DES MOINES RECREATIONAL RIVER AND GREENBELT

FEATURE DESIGN MEMORANDUM #8 WITH ENVIRONMENTAL ASSESSMENT

DOWNTOWN RIVERFRONT
PLAZA/AMPHITHEATER

SUBJECT: Response to NCD's Comments to Draft FDM No. 8,
Downtown Riverfront Plaza/Amphitheater, Des Moines
Recreational River and Greenbelt, Iowa

| Scale: AS SHOWN Date: Drawing Code: | Sheet Reference Number: S-6 | Solicitation Number: DACW29-9-8- Sheet of | |

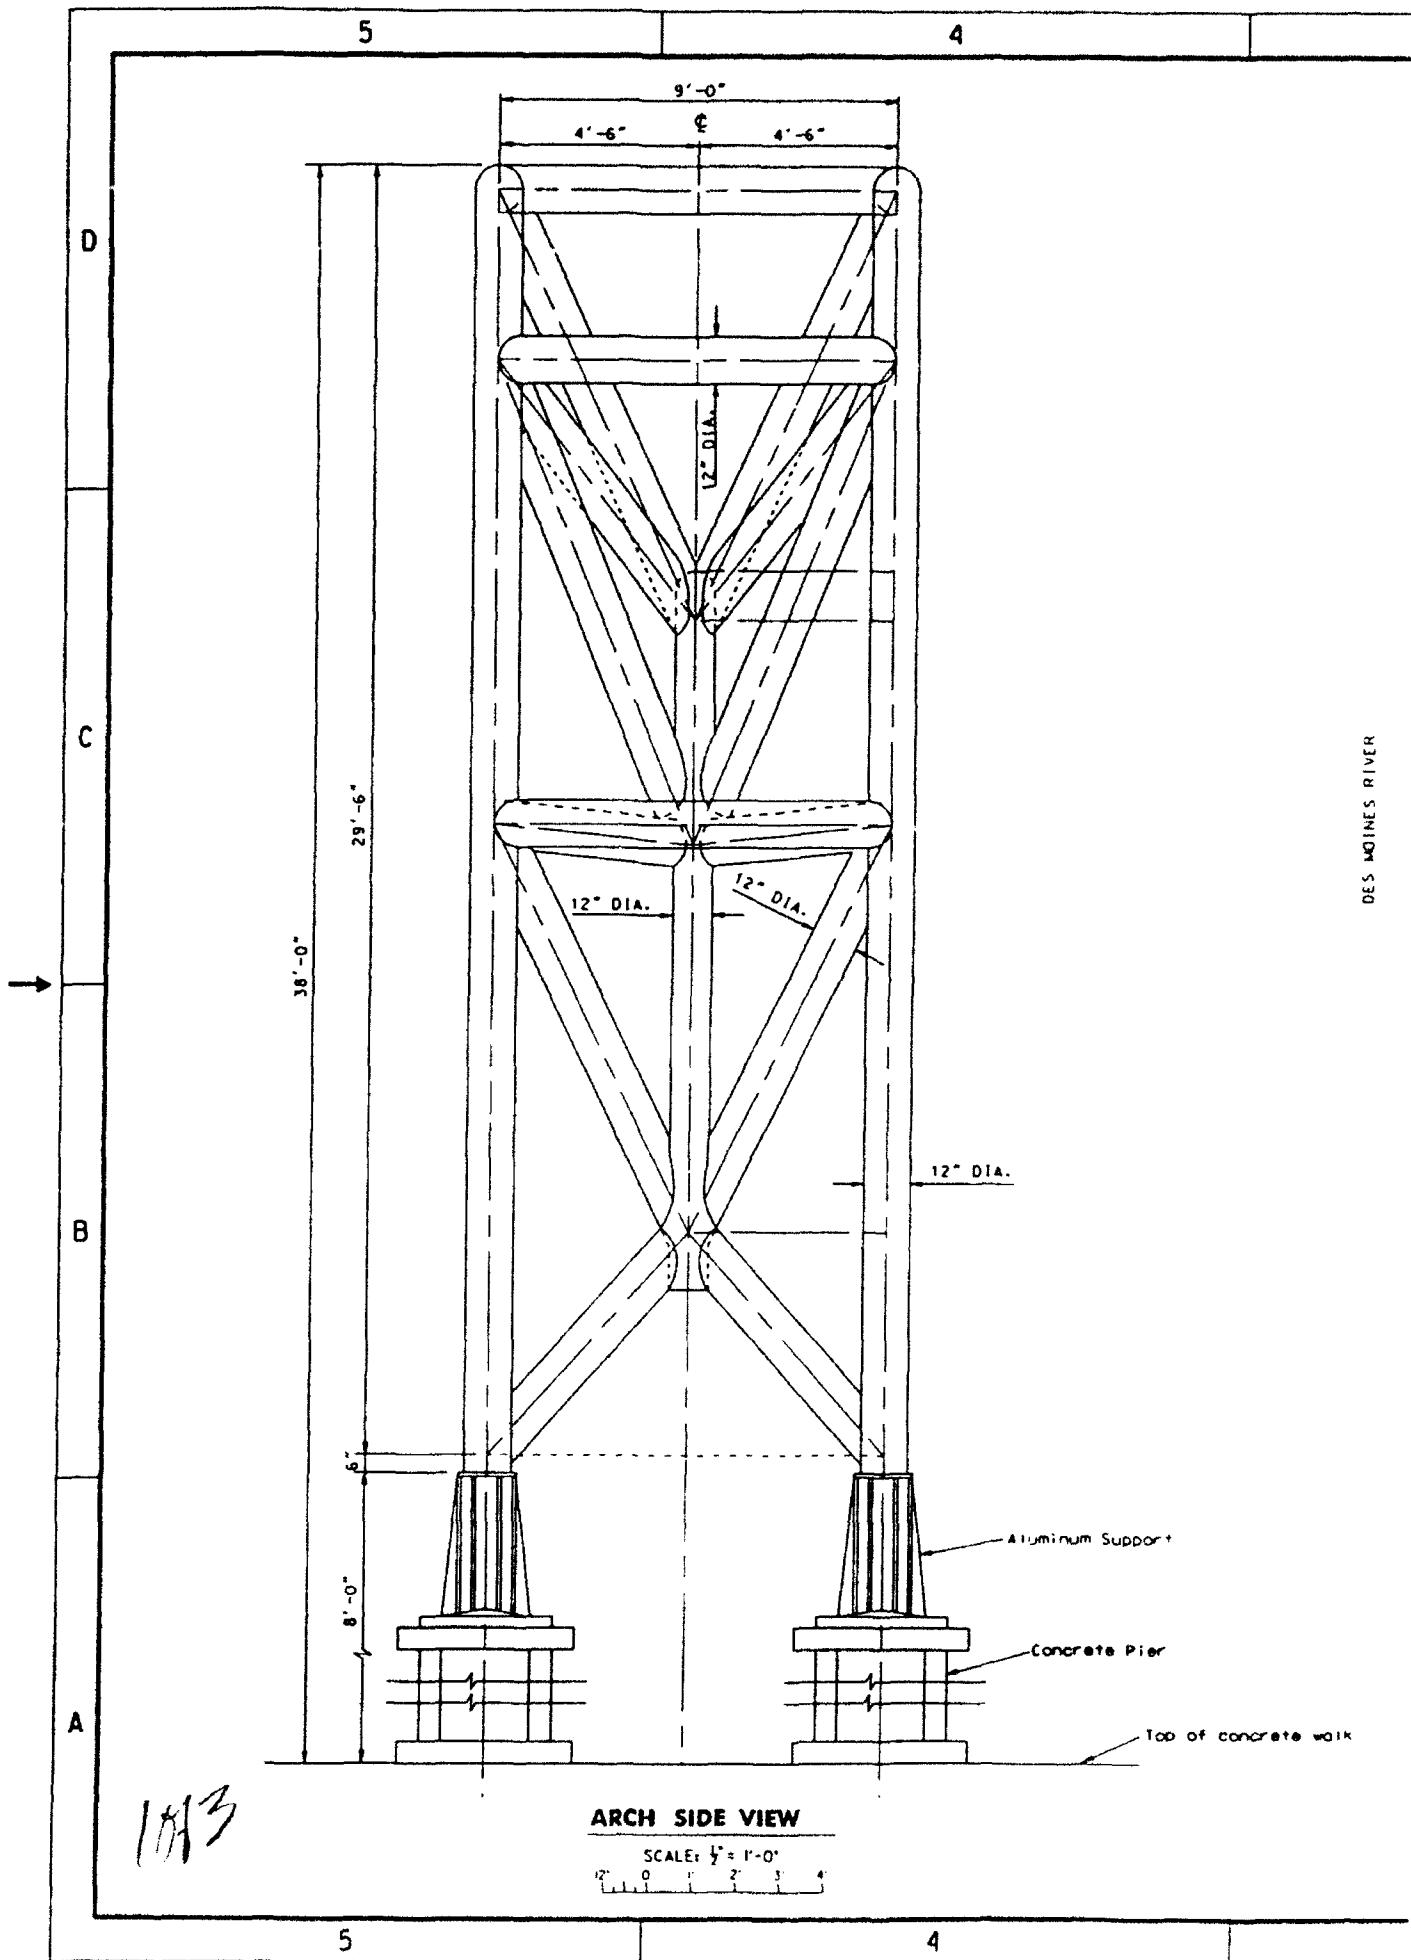
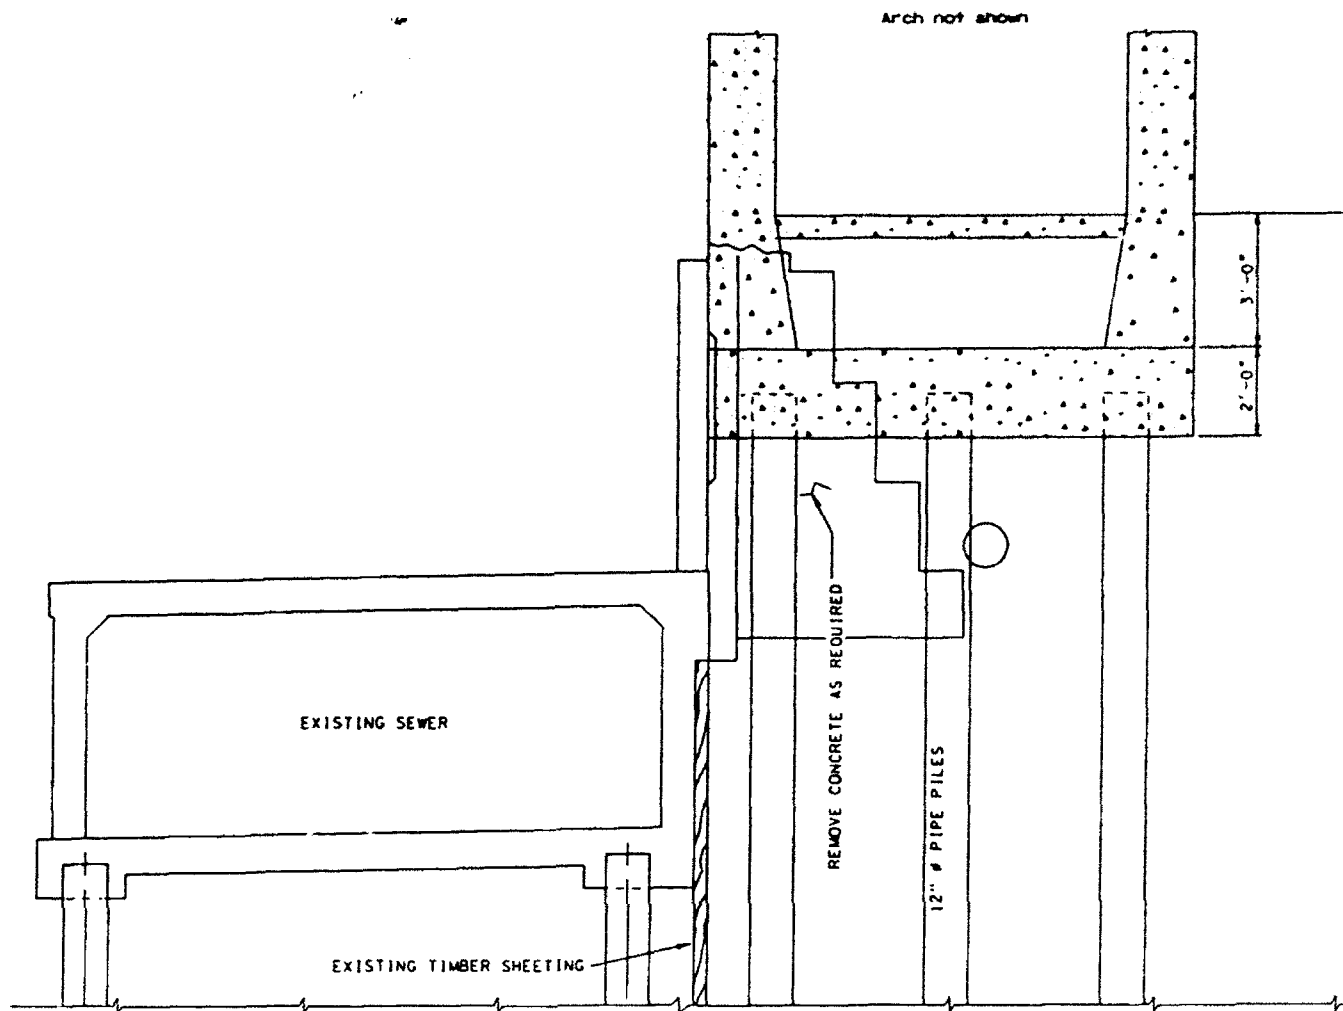
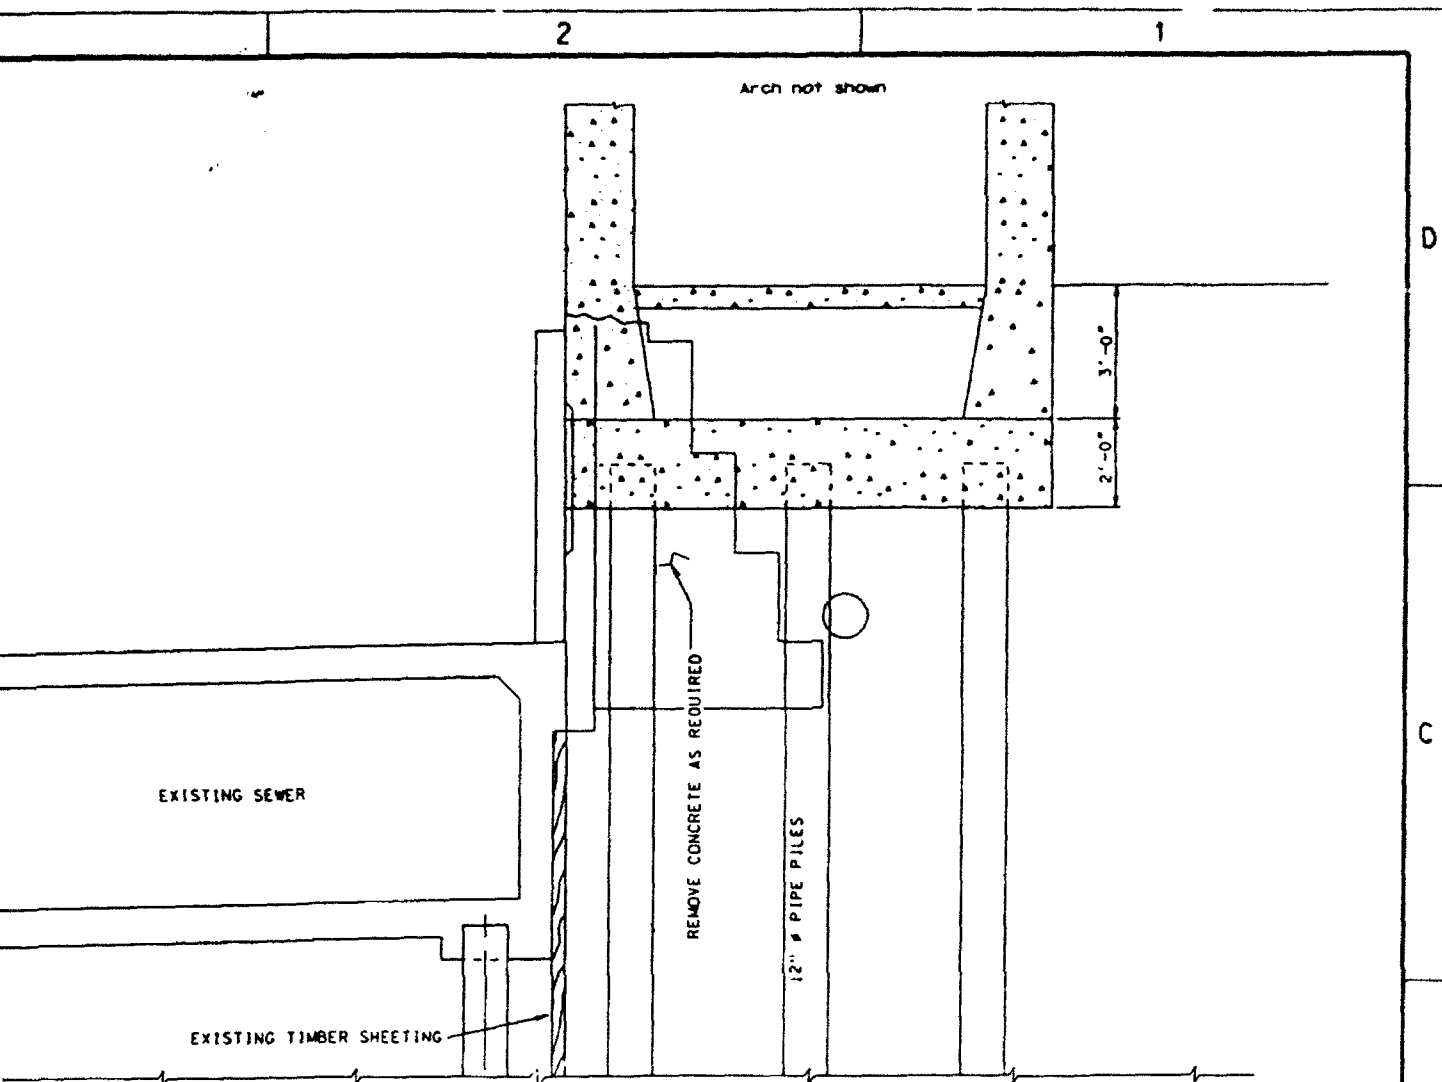
4. Computer Input. A review of the dimensions of the Arch Foundation Plan shown on Sheet S-6 would indicate that the CPGA input will require revision to more accurately reflect the weight of the foundation and overburden. Similarly, the diagonal coordinates (x) listed on Plate D-51 must be revised.

4. COMMENT: Arch foundation was analyzed with a 3'-6" c/c pile spacing. Sheet S-6 indicates 4'-0" c/c in the east west direction and 3'-6" in the perpendicular direction. Reconcile and revise as necessary.

4. RESPONSE: Both Appendix D and Plate 16 have been revised to reflect the latest analysis.

| Approved by: | Drawing Code: | S-7 | 04C425-9 -8- |

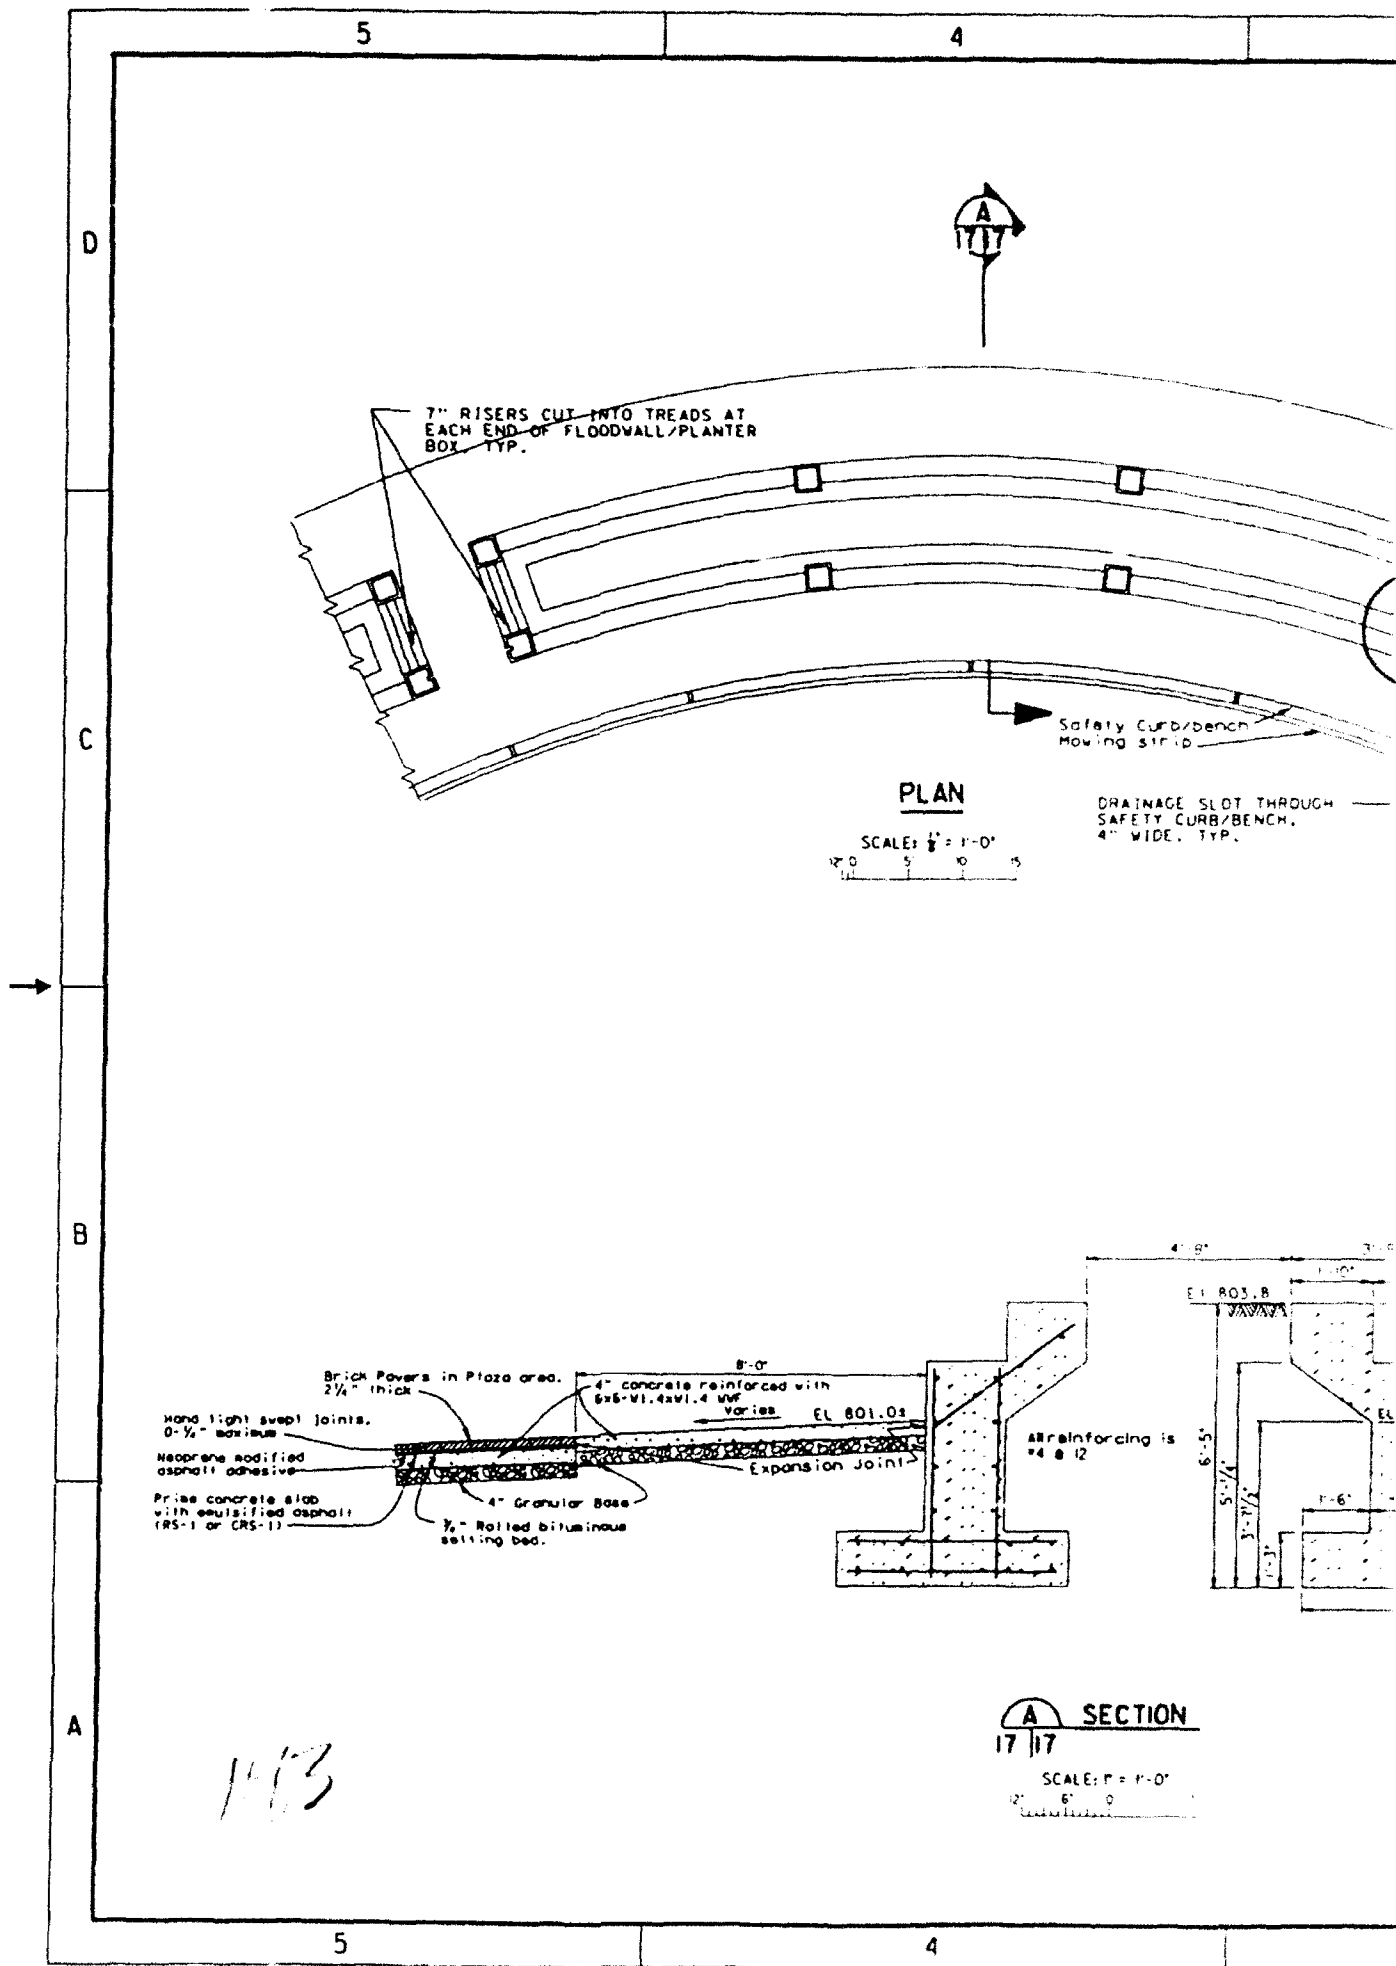
6. COMMENT: Retaining Wall Design, Plate D-65, assumed bottom of foundation E1.791 and top of stem at E1.803.8, while Drawing S-8, shows top of wall at E1.802.8 and bottom of foundation varying from E1.785 to E1.793. Verify that the assumed cross-section will be sufficient for the highest backfill level on the tallest wall. Analyze effect of wall foundation loads on existing sewer below.

6. RESPONSE: The most conservative section was chosen for analysis. The section of wall closest to the river receives no surcharge from Locust Street or the sidewalk along locust street and does not have much of a difference between the
